CONVAIR

COMMERCIAL CHANGE PROPOSAL

SPEC NO.: ZD-22-304

MODEL: 22-22 (Convair "880")

GENERAL ARRANGEMENT

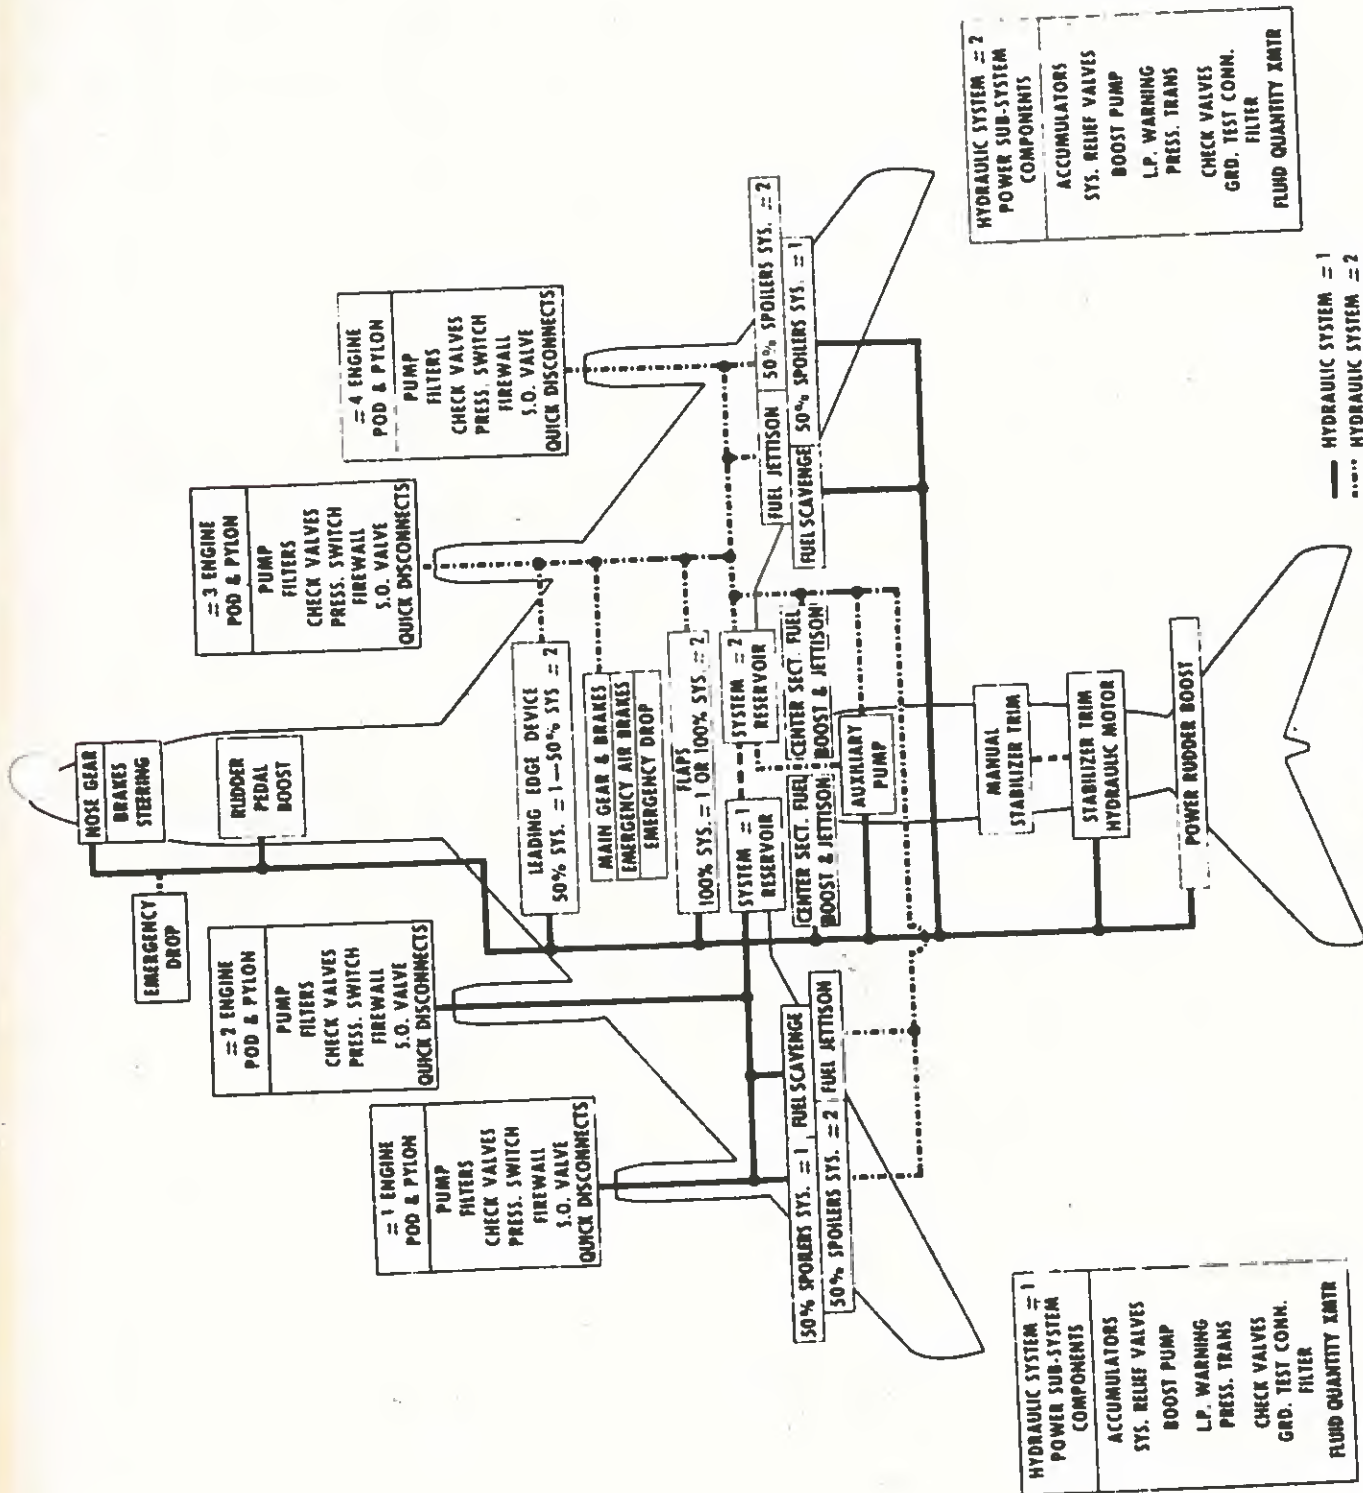
Page 3a, GENERAL ARRANGEMENT:

Replace above illustration in the specification with Enclosure (A) which shows Krueger Flap installation between inboard pylon and fuselage, and trailing edge inboard flap extension.

Enclosure: (A) One copy Page 3a - GENERAL ARRANGEMENT (Revised)

Page 7a, C. G. DESIGN LIMITS:

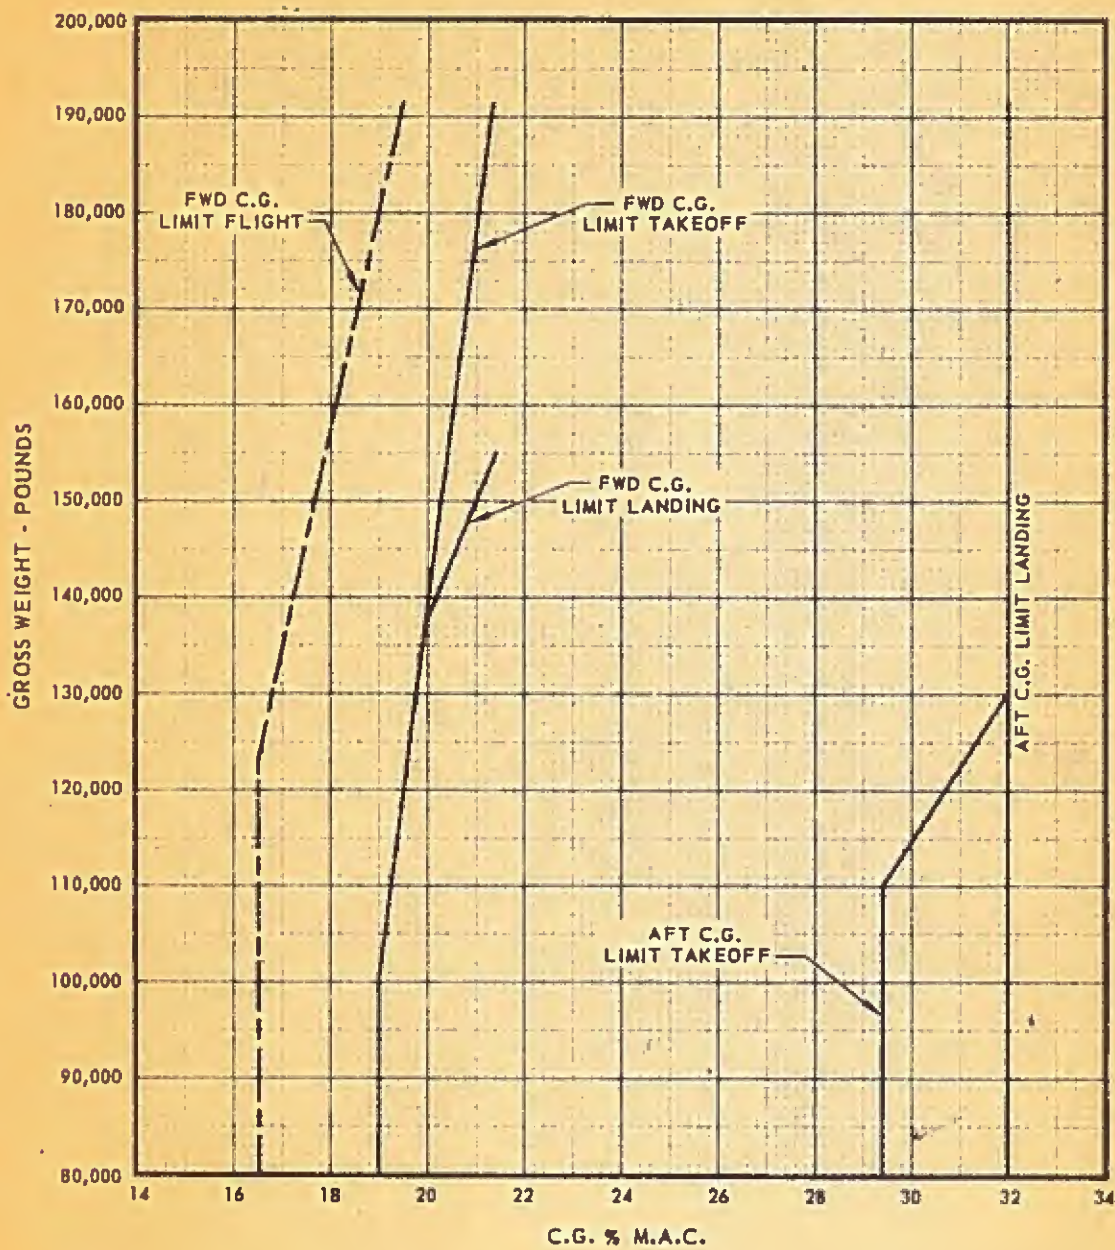
Replace above illustration in the specification with Enclosure (A) which adds new aft C. G. Limit takeoff and landing.

Enclosure: (A) One copy Page 7a, C. G. LIMITS (Revised)

Enclosure: (A) One copy of Page 99a - ESTIMATED CABIN PRESSURE SCHEDULE (Revised to show effects of the above change)

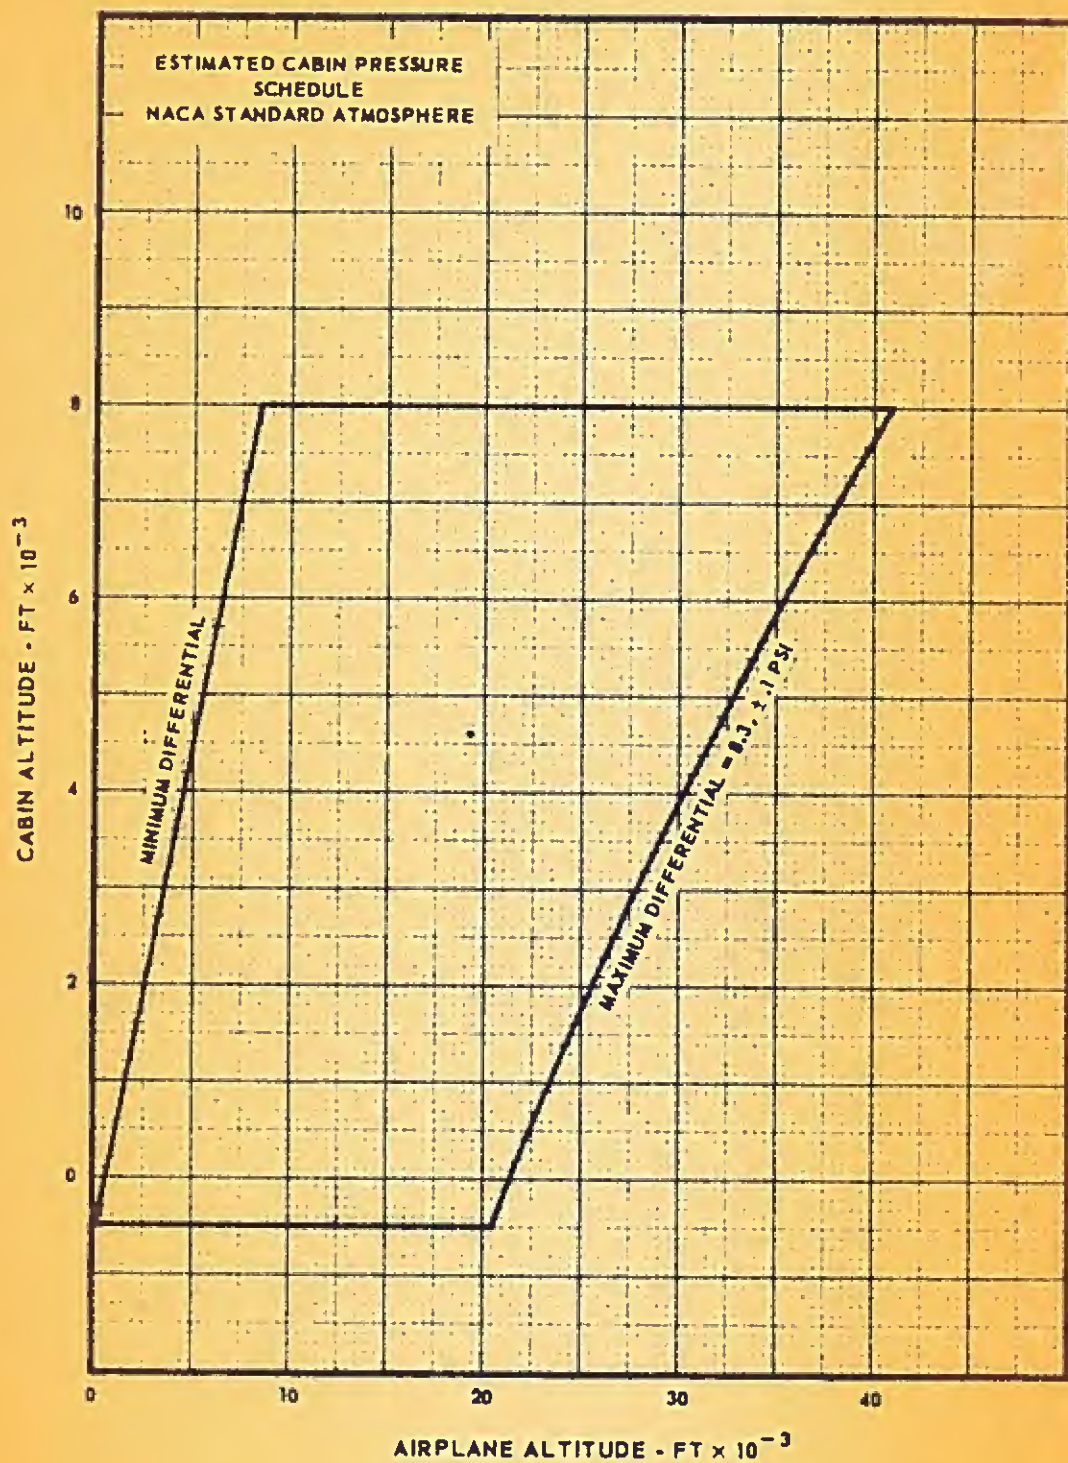
"The maximum operating altitude of the airplane shall be 41,000 feet, with an operating cabin pressure differential of 8.3 psi \pm .1 psi (See 3.20.3.1)."

In the second line, change "8.2" to "8.3 psi \pm .1 psi".

In the seventh line, change "8.2" to "8.3 psi \pm .1 psi".

The above illustration will be revised to show effects of this change.
